Access Compliance Report

Public Rights-of-Way

Intersection ID: 31201	Main Street: WRAYHILL_DR	Cross Street: OLDCORN_LN	Location: SE
ADA ID: 60D3897B73AC	Ramp Type: PerpDiag	Initial Pass/Fail: Fail	Overall Compliance: No
		Severity Score: 0

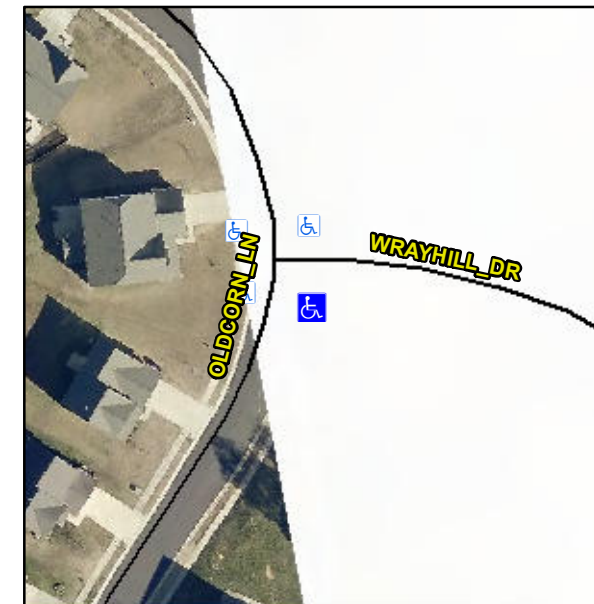
Compliance	Description	Data	Compliance	Description	Data
N/A	Ramp Length (in)	50.0	Yes	Ramp Slope (%)	7.6
Yes	Ramp Width (in)	52.0	Yes	Ramp XSlope (%)	0.1
N/A	Flare Type LT	N/A	N/A	Flare Type RT	N/A
N/A	Flare Slope LT (%)	N/A	N/A	Flare Slope RT (%)	N/A
N/A	Flare Traversable LT?	N/A	N/A	Flare Traversable RT?	N/A
N/A	Landing Length (in)	N/A	N/A	DWS Provided?	N/A
N/A	Landing Width (in)	N/A	N/A	DWS Contrast?	N/A
N/A	Landing Slope (%)	N/A	N/A	DWS Length (in)	N/A
N/A	Landing X Slope (%)	N/A	N/A	DWS Full Width?	N/A
N/A	Landing Curb? (Y/N)	N/A	N/A	DWS Offset (in)	N/A
N/A	Shared Landing?	N/A			
N/A	Gutter Ponding?	N/A	N/A	Gutter Slope (%)	N/A
N/A	Gutter Lip Ht (in)	N/A	N/A	Gutter X Slope (%)	N/A
N/A	Painted X Walk1?	No	N/A	Painted X Walk2?	No
	X Walk 1 Direction	To N		X Walk 2 Direction	To W
N/A	X Walk 1 Width (in)	N/A	N/A	X Walk 2 Width (in)	N/A
	X Walk 1 Slope (%)	1.2		X Walk 2 Slope (%)	3.4
	X Walk 1 X Slope (%)	3.6		X Walk 2 X Slope (%)	1.3

Remove & Replace Curb Ramp With Two New Directional Ramps or Equivalent.
